# URBAN DESIGN COMMITTEE

2. Mixed-Use Residential building at [1000 S 13th St. – UDR24079](#) – *Final Action*

## URBAN DESIGN COMMITTEE STAFF REPORT

# CENTER TERRACE

**Staff comments:**

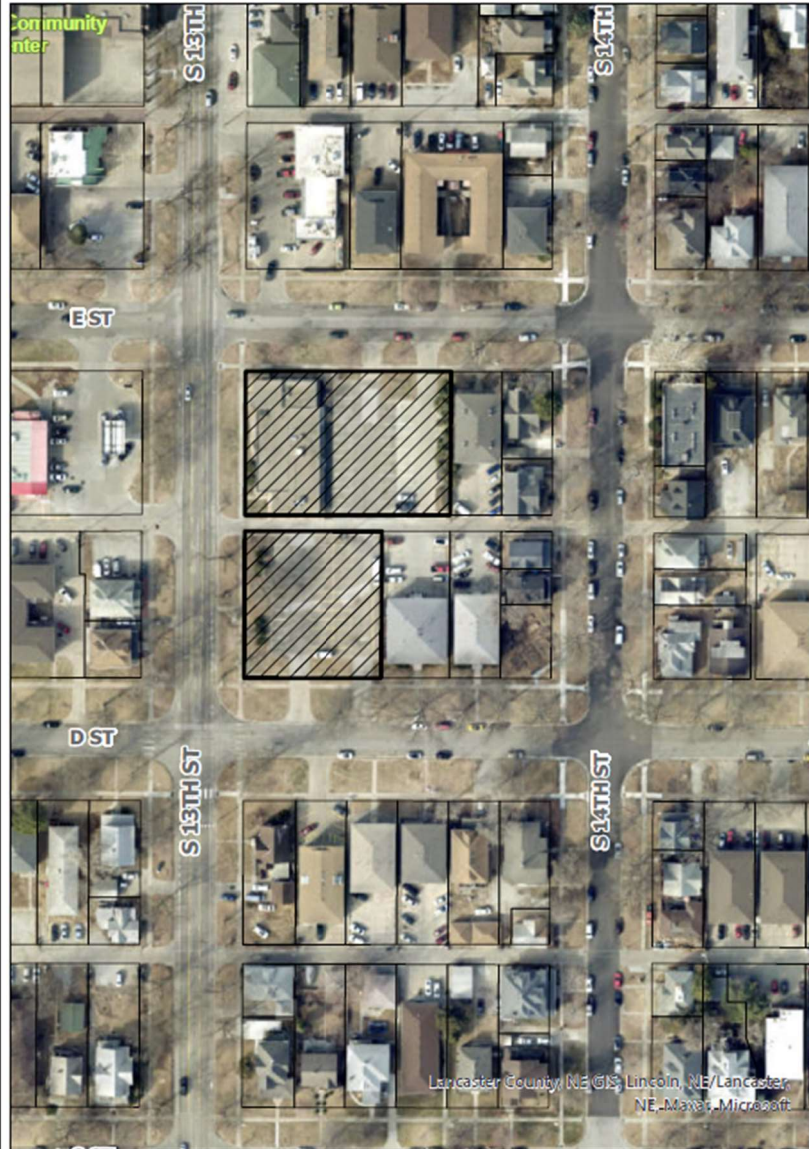
Although the proposed design is not in conformance with the Neighborhood Design Standards due to its scale in relation to its neighbors, the planning department acknowledges the deliberate incorporation of certain neighborhood elements in the design. These design moves attempt to maintain a sense of continuity and architectural cohesiveness within the community, and are essential for community building. Moreover, the project also aligns with the City's policies and goals mentioned in the Comprehensive Plan.
